ECONOMISER ASSEMBLY

DRG NO : EC-01-GA-001

BOM CHECK SUMMARY

Drawing : sample_01_drawing.pdf (Rev B)
BOM : sample_01_bom.xlsx (Rev B)
Input : vector PDF
RUN RELIABILITY : HIGH

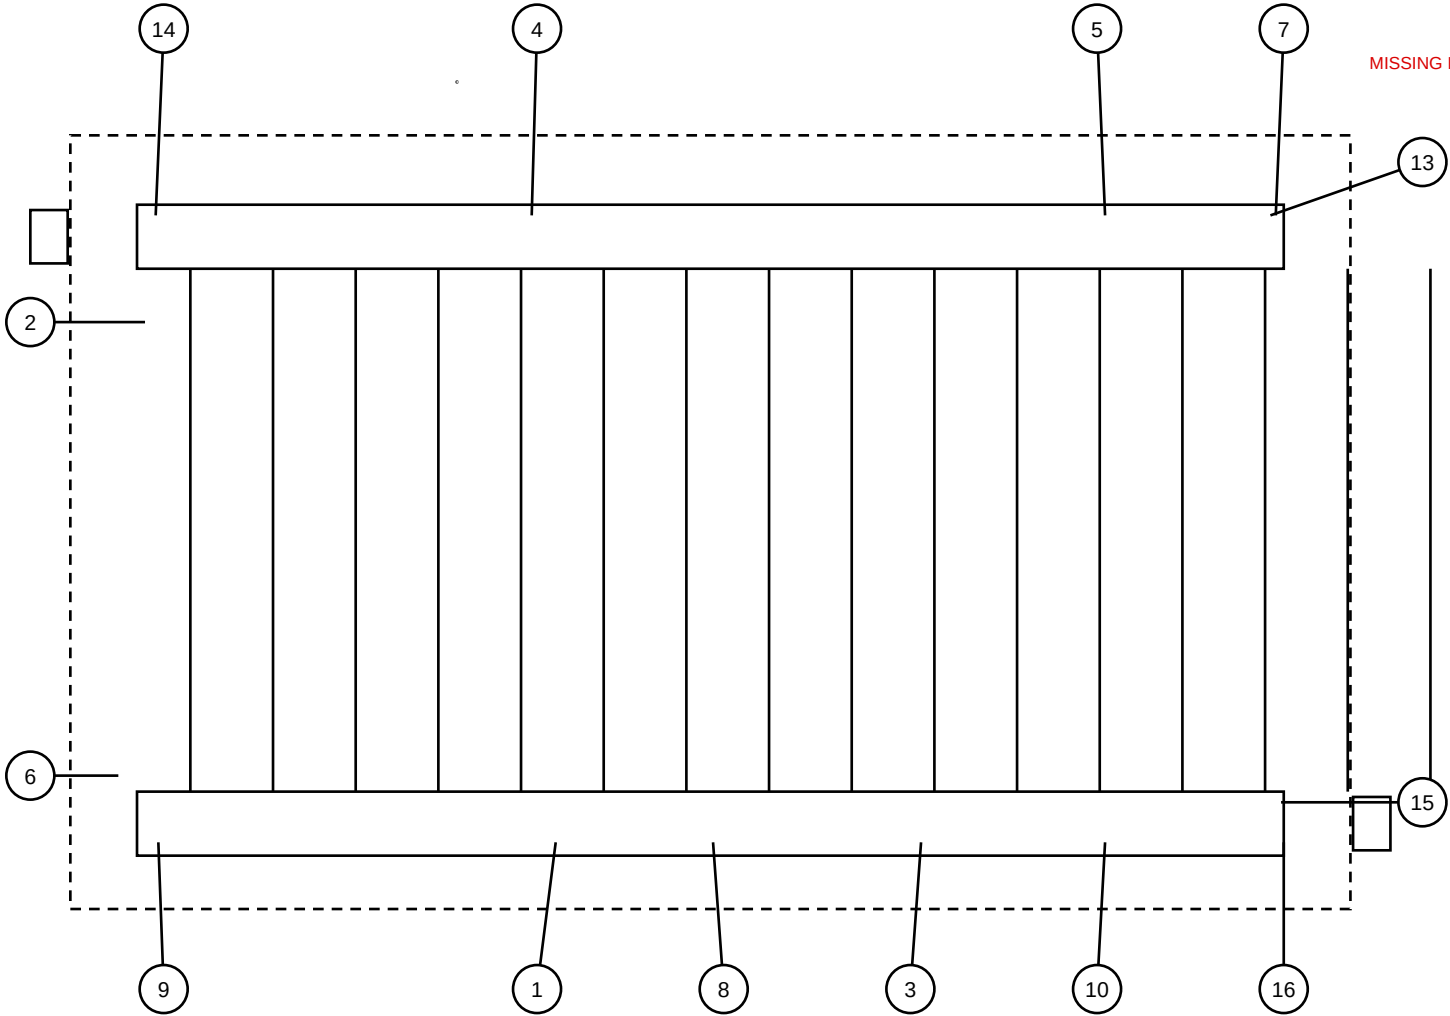
3. INSULATE WITH 100 THK MINERAL WOOL AND CLAD WITH 0.6 THK ALUMINIUM SHEET. <- BOM LACKS: Cladding

[RED] Item 12 'STUD BOLT M20 X 90 WITH 2 NUTS' (qty 16) is on the drawing but has no BOM line
[ORANGE] Item 6: specification mismatch - dimension: drawing ['200'] vs BOM ['250']
[YELLOW] BOM row 23 'Outlet header 219.1 OD x 8 thk' repeats item 2 (already covered by BOM row 7)
[BLUE] Suggestion (Cladding): the drawing notes imply it, but no matching line was found in the BOM
